FINAL ENVIRONMENTAL IMPACT STATEMENT

Hydroelectric Power Development

UPPER SUSITNA RIVER BASIN SOUTHCENTRAL RAILBELT AREA, ALASKA

DEPARTMENT OF THE ARMY
ALASKA DISTRICT, CORPS OF ENGINEERS
P.O. BOX 7002
ANCHORAGE, ALASKA 99510

FIGURE 3
8

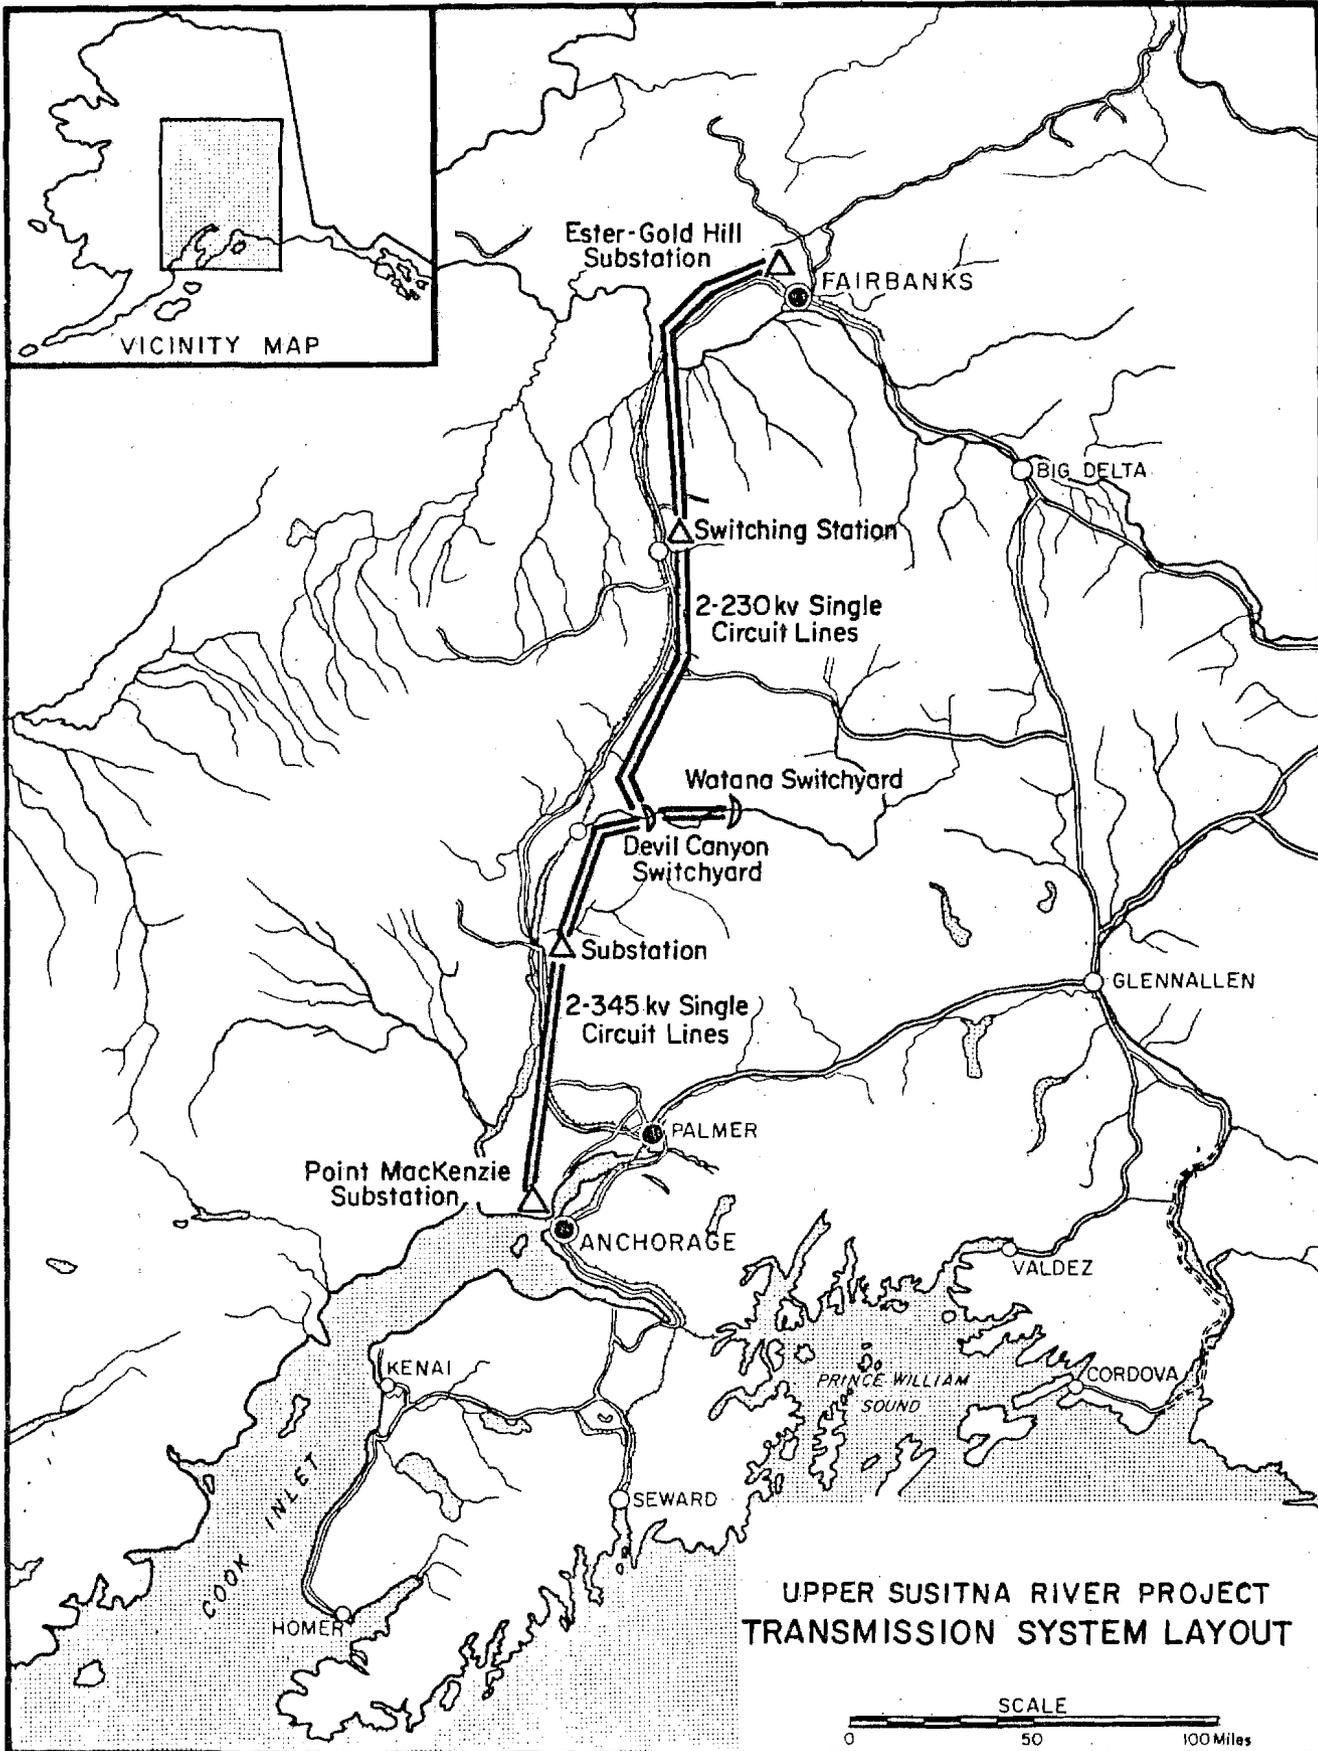
Figure 3 (page 7) is so sketchy as to be useless for assessing relationships between the transmission corridor and even basic terrain features. Figure 4 (page 11) is unreadable.

FIGURE 7

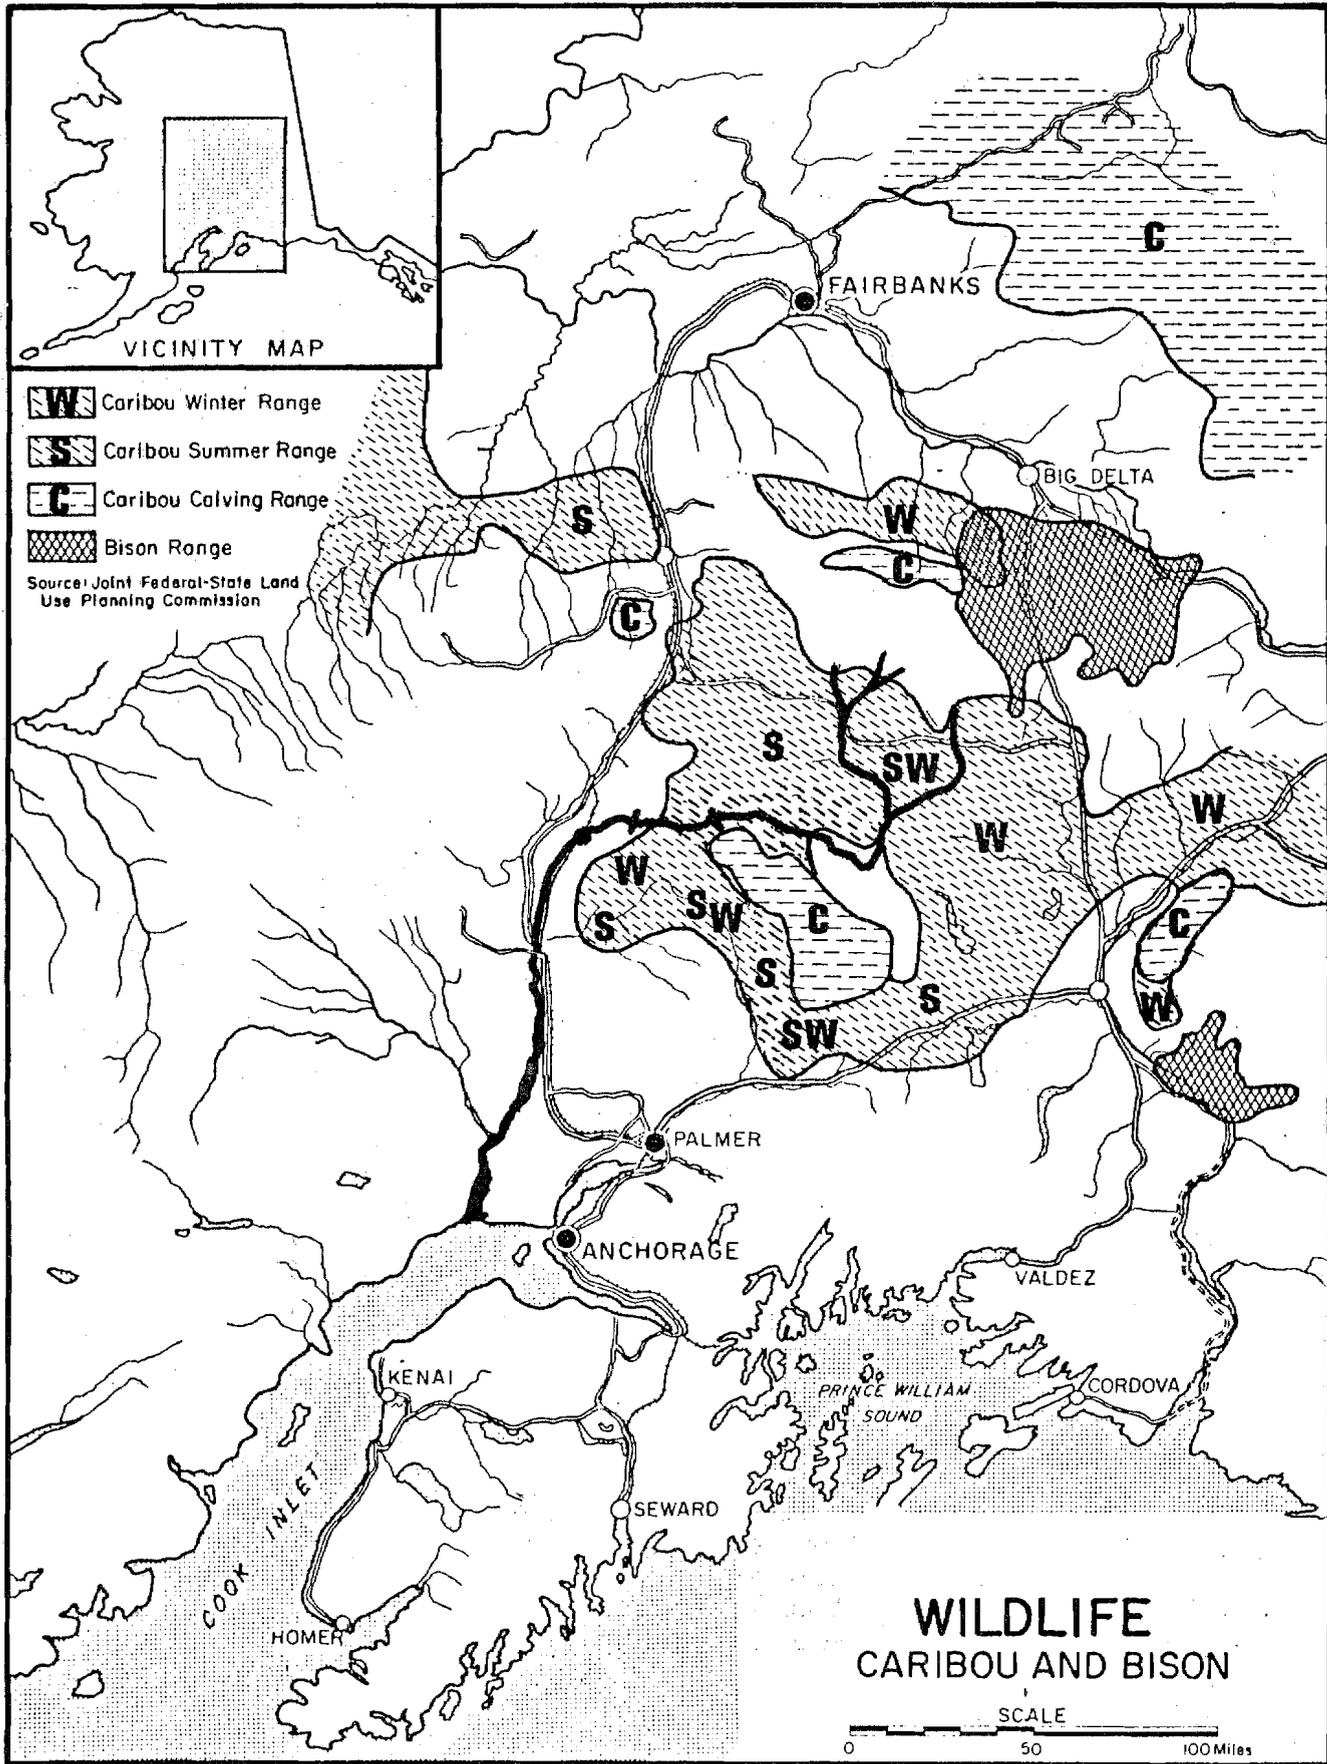
- 138 Page 24, Figure 7 - The white (unmarked) area in the center of the caribou range map is both summer and winter range. This area should be so indicated.

FIGURE 9

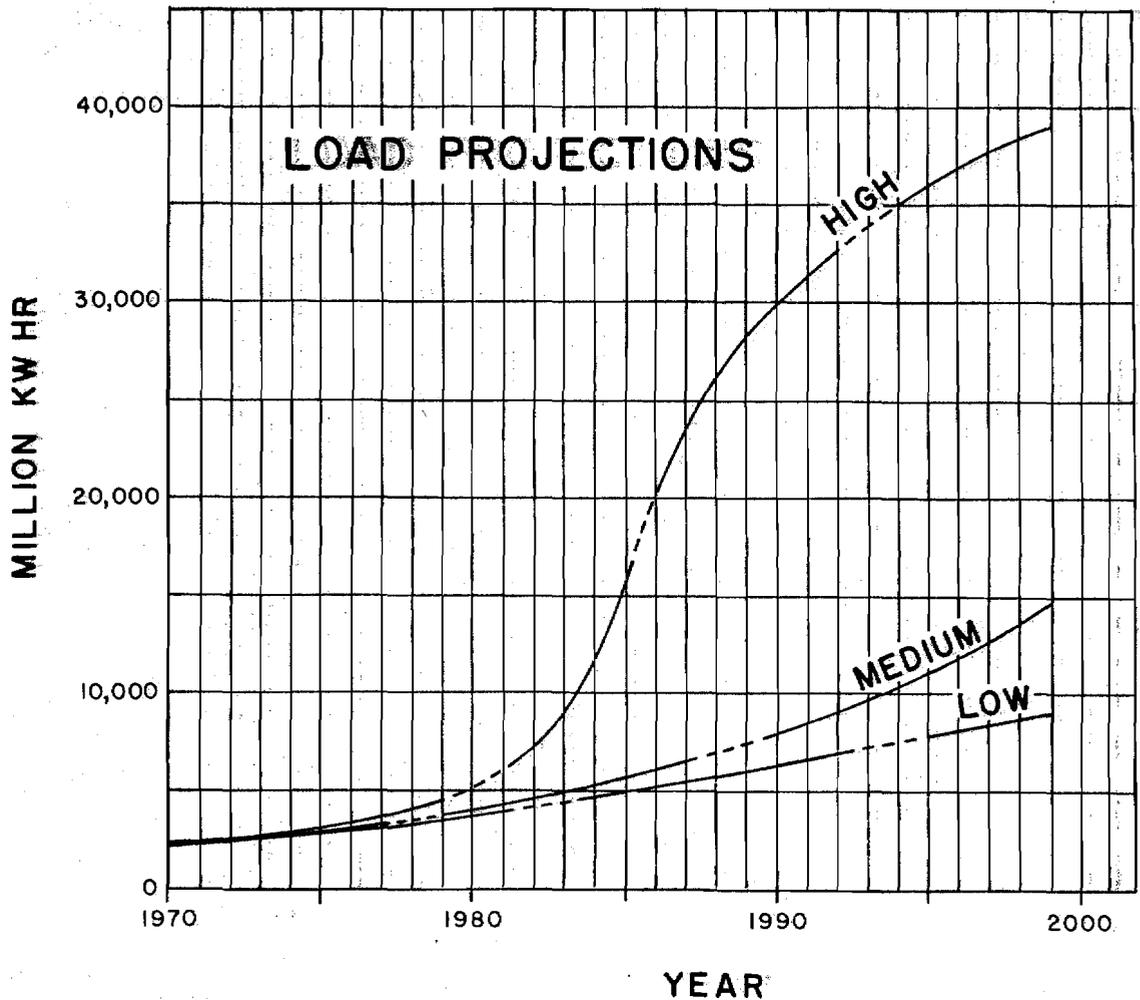
- 79** An entire section (2.04) is devoted to a discussion of energy needs. Figure 9 is a graph which illustrates a five-year record of energy consumption (1970-1974) plus projected load growth through the year 1999.

FIGURE 15

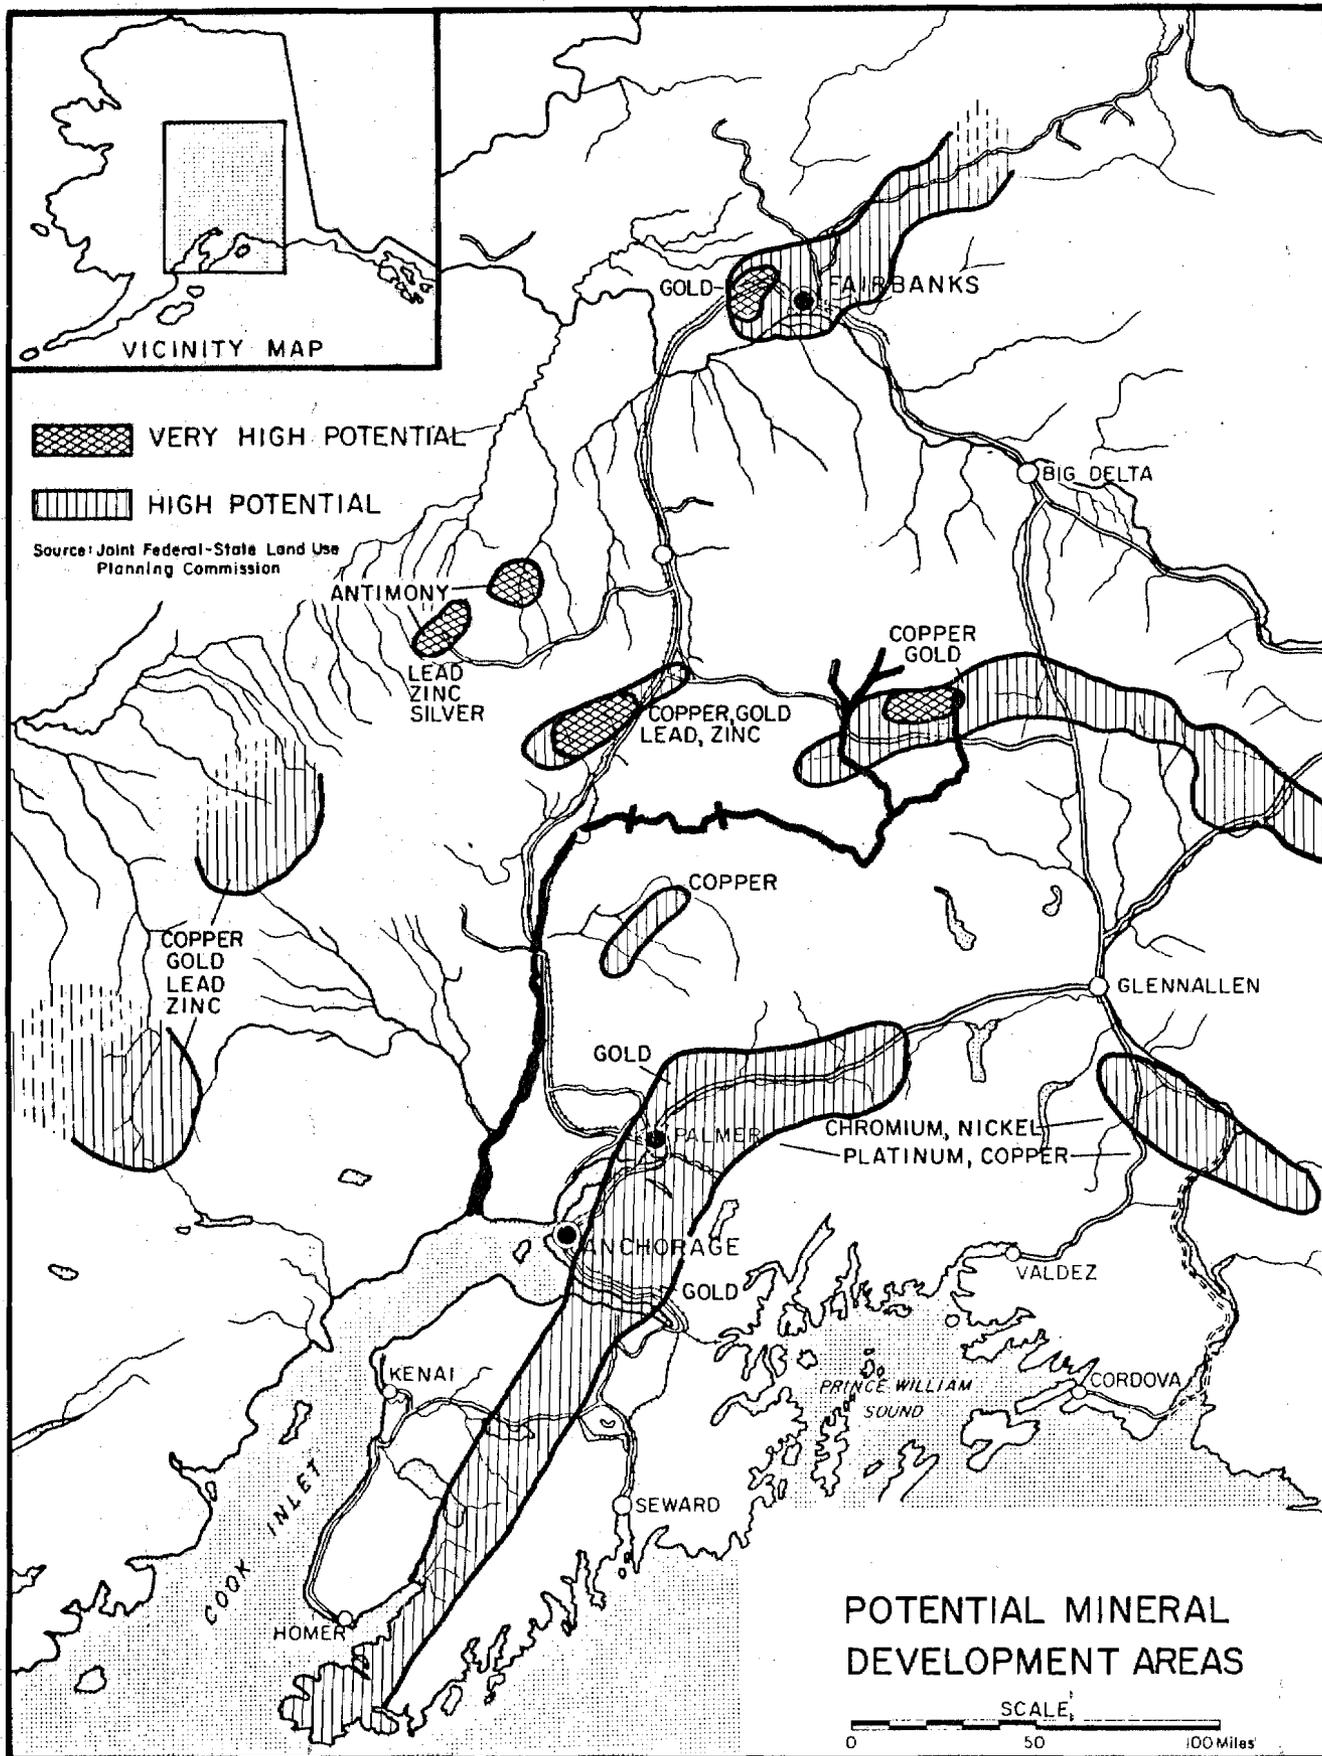
A transmission corridor is indicated in figure 15 as possibly passing through the Copper River Basin served by the Copper Valley Electric Association which has plans to increase their service by a new hydroelectric project at Solomon Gulch near Valdez with a transmission line to the Copper River Basin. The coordination of these two transmission or power systems should be explained in the final.

The second reason we consider the alternatives for power transmission corridors inadequate is that there is no analysis of impacts. Figure 15 graphically presents the alternatives. The text then states that the proposal was selected on the basis of cost, reliability, and potential environmental impact, but none of the needed information is presented. An environmental statement should present enough information for the reader to understand why the proposal was selected over the alternatives.
